Technical Service Bulletin: TSB190035

Cylinder Liner Installer Kit 3164606 Update

Figure 2, Left: Incorrect Spacer Arrangement. Right: Correct Spacer Arrangement.

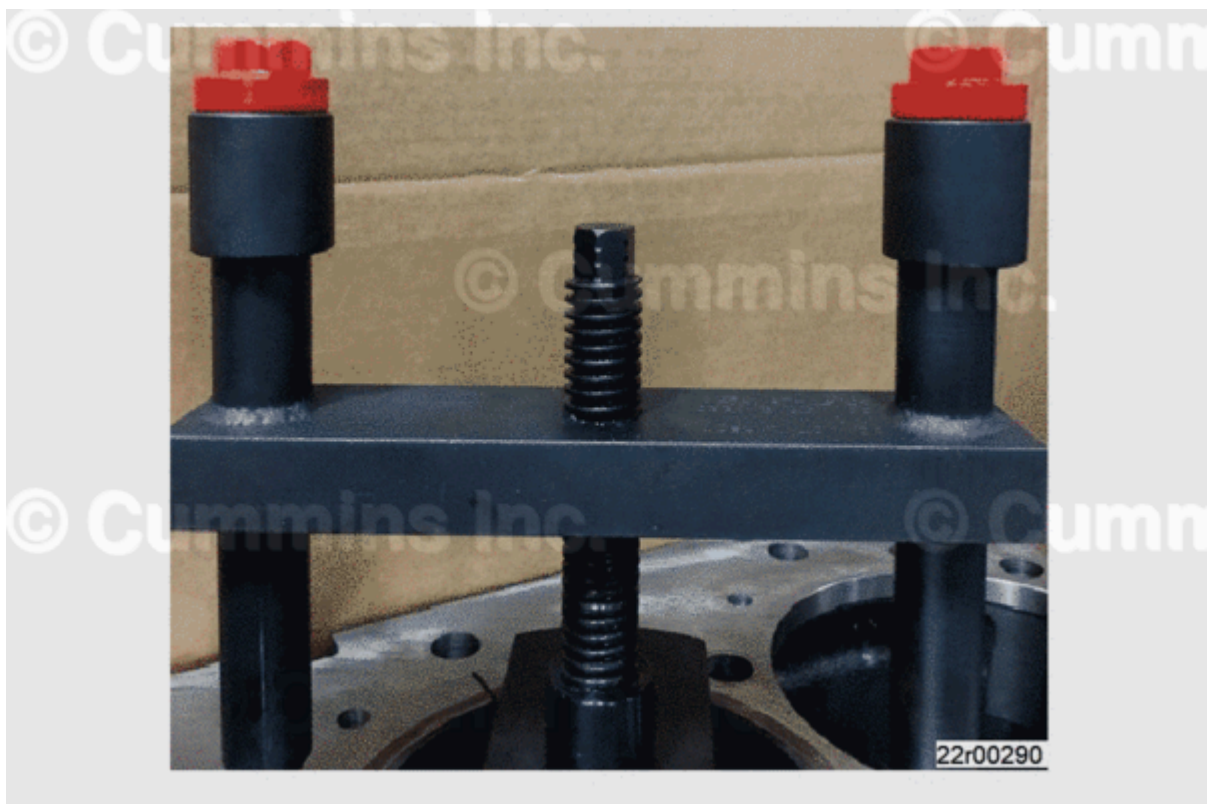
Lack of adequate thread engagement when using liner installation kit, Part Number 3164606. Short head bolts can lead to stripped head bolt threads or damaged cylinder block threads.

Cylinder blocks are now machined with a deeper cylinder head bolt counterbore that prevents adequate thread engagement when using the short head bolts. The long head bolts are too long to use without spacers.

Existing Kit, Part Number 3164606, has been updated to include spacers, Part Number 5395470, that allow the longer cylinder head bolts to be used with the kit to achieve adequate thread engagement.
